## HISTORIC AND DESIGN REVIEW COMMISSION

**HDRC CASE NO:** 2024-106  
**ADDRESS:** 2619 MCCULLOUGH AVE  
**LEGAL DESCRIPTION:** NCB 1704 BLK 12 LOT N1-2 OF 12 & 13  
**ZONING:** O-1, H  
**CITY COUNCIL DIST.:** 1  
**DISTRICT:** Monte Vista Historic District  
**APPLICANT:** Bertha Zuniga/Zuniga Law, PLLC  
**OWNER:** Bertha Zuniga/Zuniga Law, PLLC  
**TYPE OF WORK:** Fenestration modifications and infill of eight wood windows  
**APPLICATION RECEIVED:** March 07, 2024  
**60-DAY REVIEW:** May 6, 2024  
**CASE MANAGER:** Claudia Espinosa

1. Remove and infill eight wood windows on the north and south façade of the second-floor enclosed porch.
2. Replace the five existing operable windows on the south façade with fixed windows.

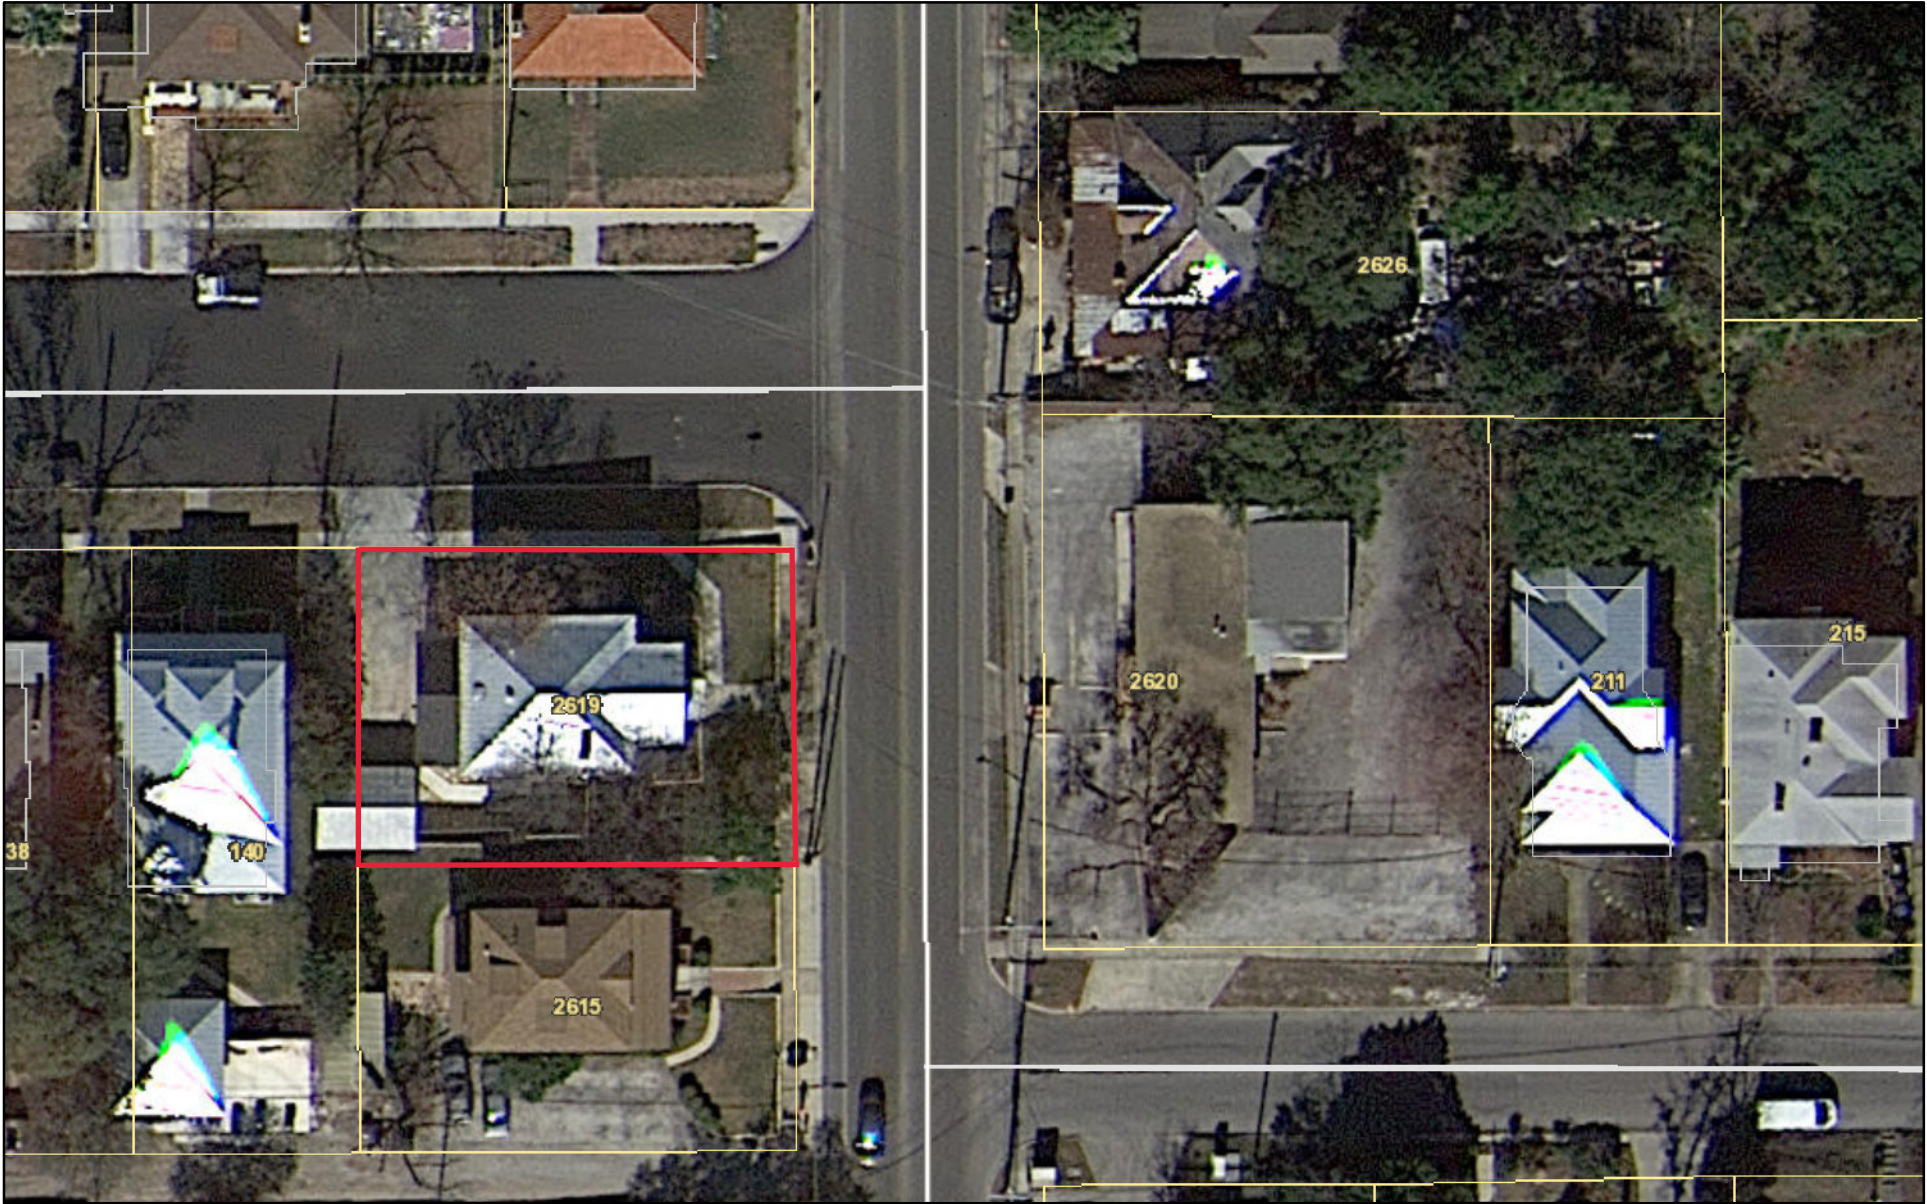
d. WINDOW REPLACEMENT (SOUTH FAÇADE) – Per the photos taken on the site visit, staff was able to locate additional windows that have been modified without approval. Per the Guidelines for Exterior Maintenance and Alterations 6.B.iv, Install new windows to match the historic or existing windows in terms of size, type, configuration, material, form, appearance, and detail when original windows are deteriorated beyond repair. Staff has not been able to assess any windows prior to the modifications were made. At this time, staff finds that the applicant submits a window schedule, photos of the interior and exterior of each window requested for replacement, numbered to correspond to the floor plan, material specifications of the existing windows, photos or manufacturer's specifications, including material specifications, for the proposed replacement product (typically in the form of a cutsheet) to staff for review.

Modifications on the south facade, circa 2024

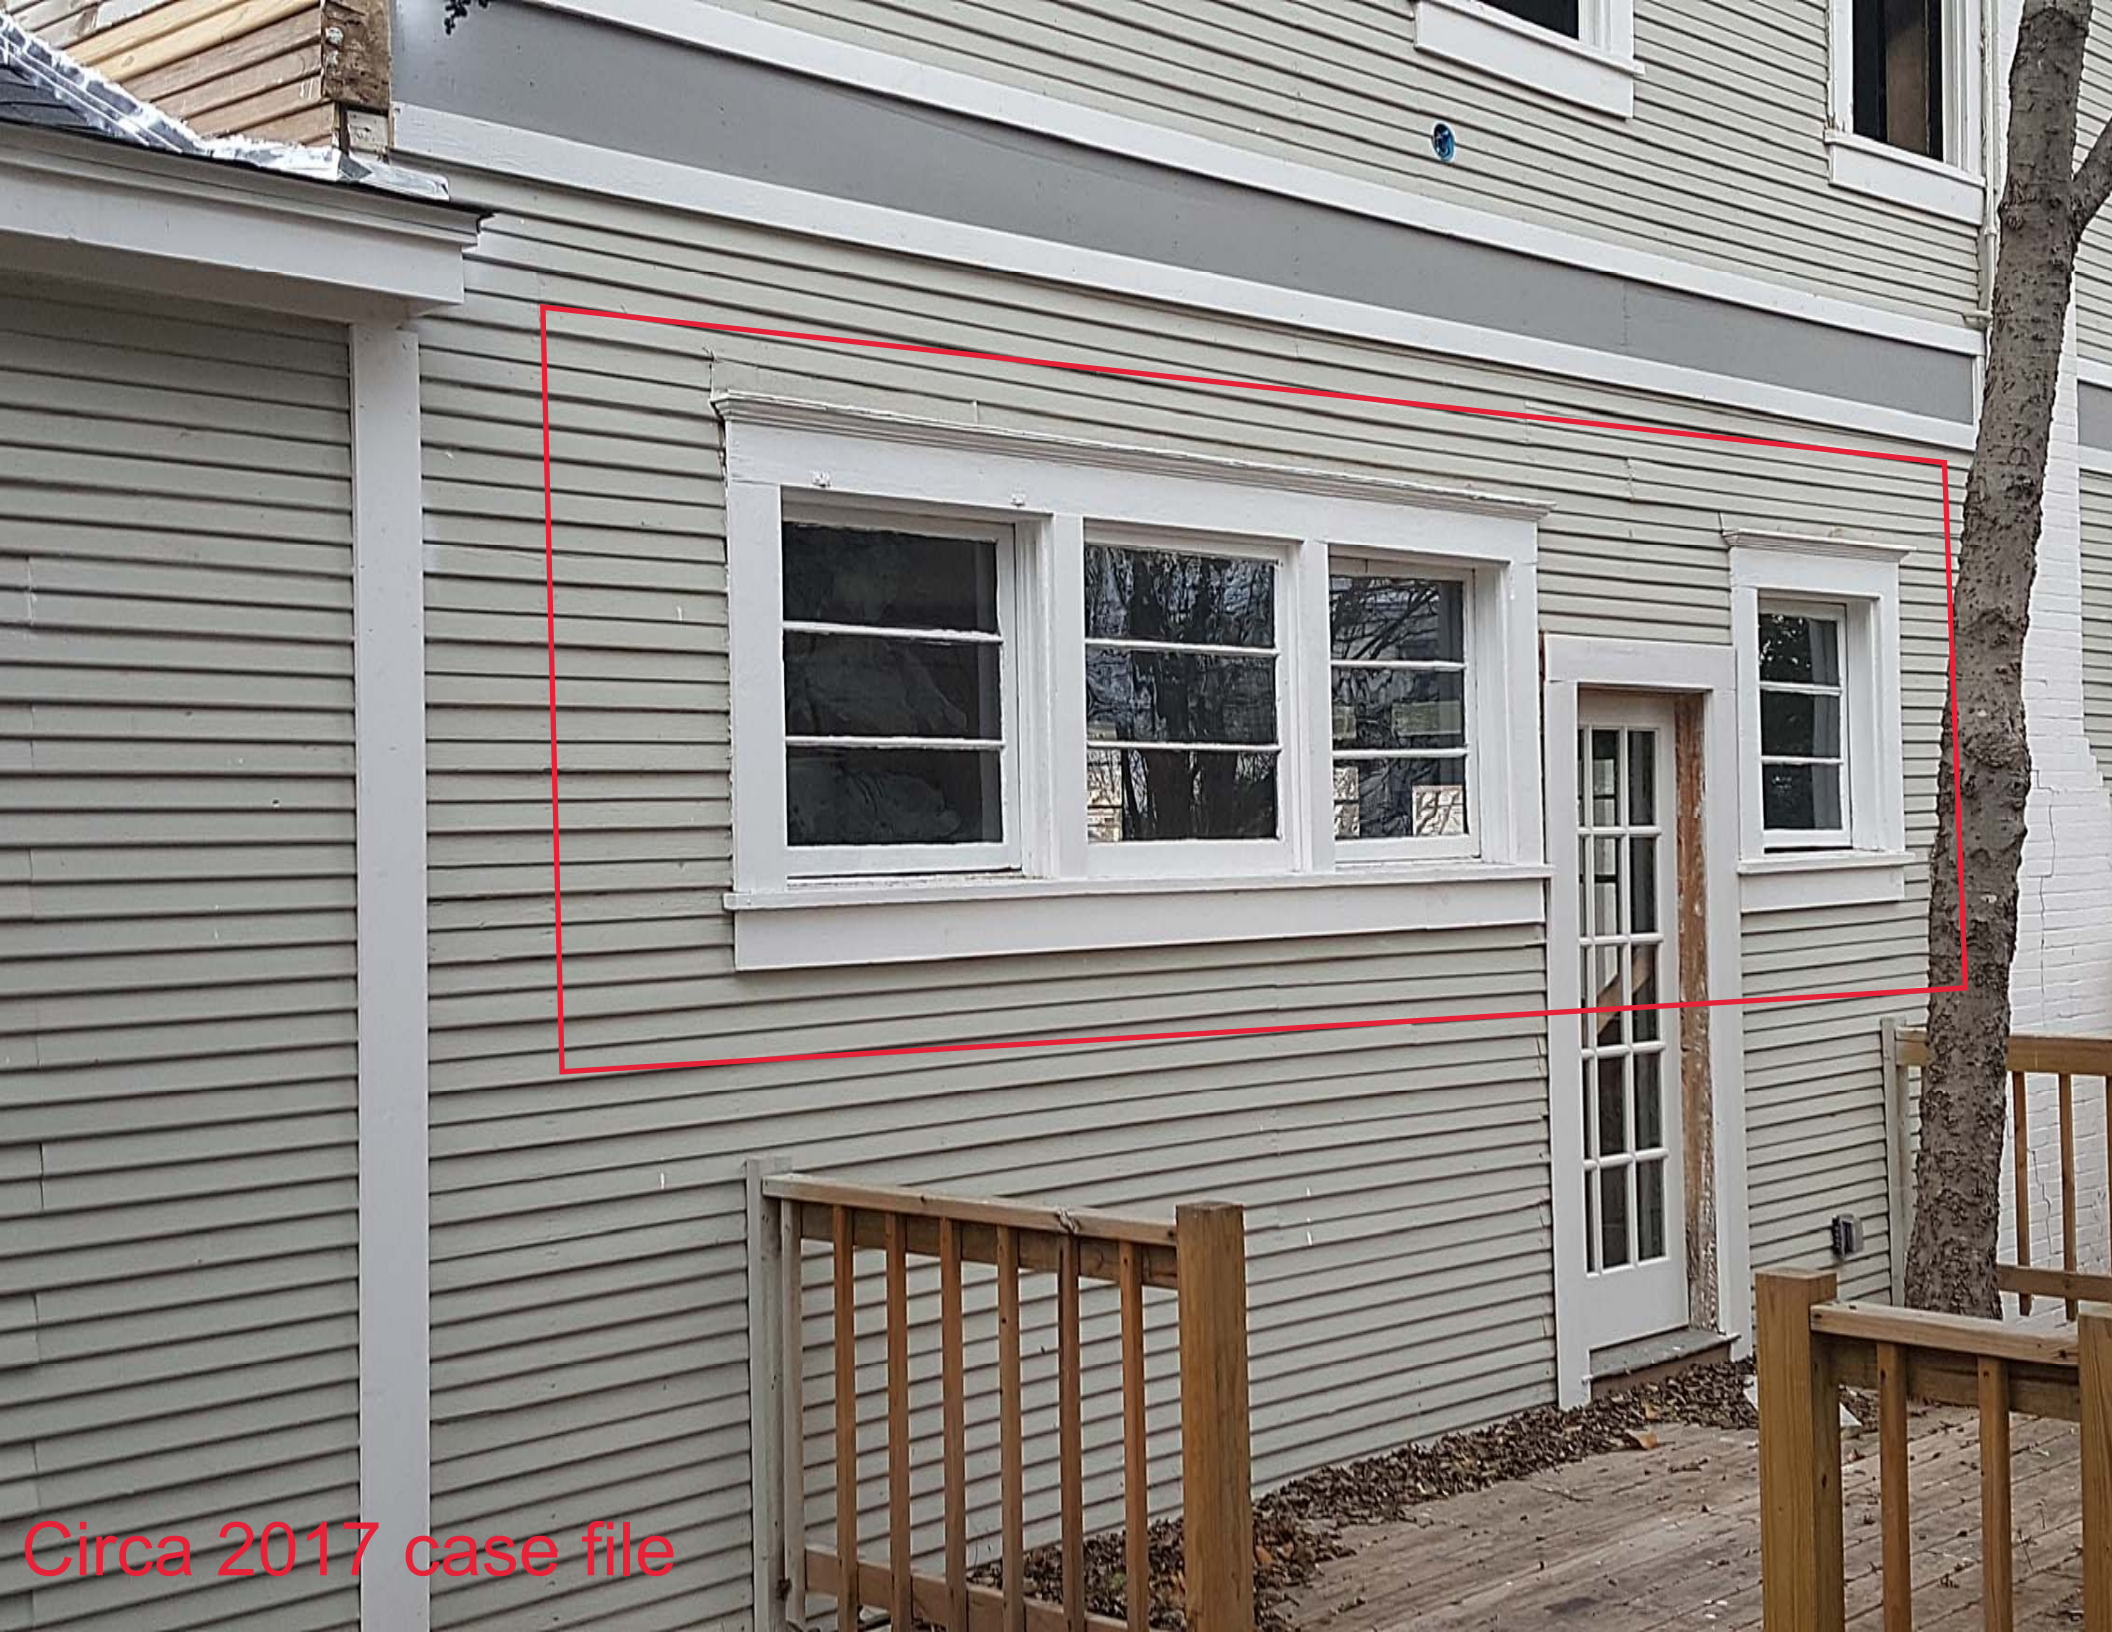
e. WINDOW OPENING MODIFICATION (SOUTH FACADE) – The applicant has proposed to modify five (5) window opening on the south façade of the original structure by shortening the overall size of the opening. The Guidelines for Exterior Maintenance and Alterations 6.A.i. notes that existing window and door openings should be preserved. Staff finds the proposed modifications to be inconsistent with the Guidelines.

Item 2, staff does not recommend approval of the window replacement on the south façade, based on finding d. Staff recommends that the applicant reinstall the wood windows that were previously in place or a salvaged product that replicates the previously installed windows in size, operation, design, and configuration.
